Product Bulletin

Issue no. 97 / Aug 2014

Subject: CLAAS LEXION feederhouse chain slat support rings on front roller

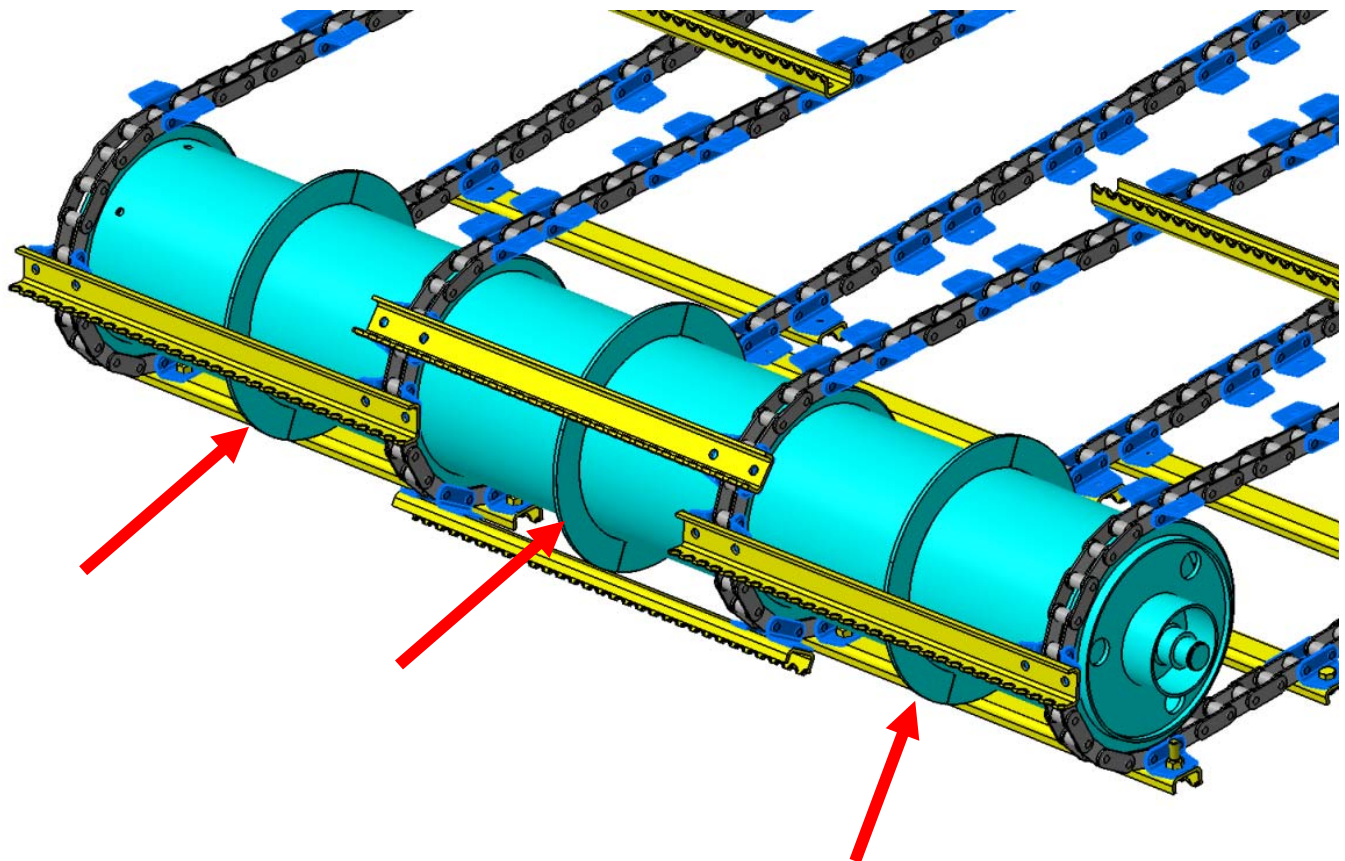
Since the introduction of the CLAAS LEXION 500 Series in 2005, the feederhouse front roller has been enclosed for gentle crop handling (corn) and enhanced rock protection. With the increased use of draper heads on LEXION combines, additional rock protection, especially to prevent bending chain slats, has been requested.

Therefore, CLAAS Engineering and Product Management made weld-on support rings available through parts.

The weld-on rings are installed centered between the chain rings on the feederhouse front drum. Please refer to the OMM for proper procedure when welding on CLAAS equipment.

PN: 518 959.0 (each)

Note: order 6 pieces (518959.0) when ordering
